FIELD INSPECTION

Project Name:	Mountain Valley Pipeline	Inspector:	Marshall Willis
Inspection Date:	Wednesday, April 3, 2019	Project Contact:	Brian Clauto
Spread I: Pittsylvania County	Transco Interconnect	Weather (Wet/Dry/Rain):	Dry

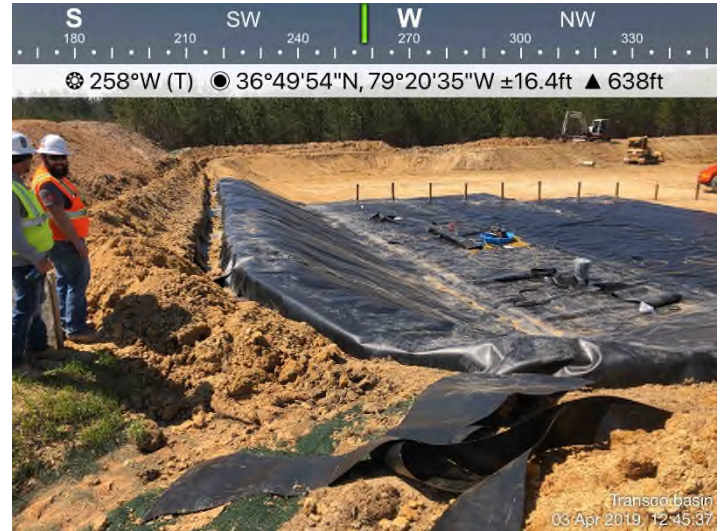
Fig. 5: **Permanent Stormwater Pond** – Installation of baffles and pond liner.

Fig. 6: **Permanent Stormwater Pond** – Installation of baffles and pond liner.
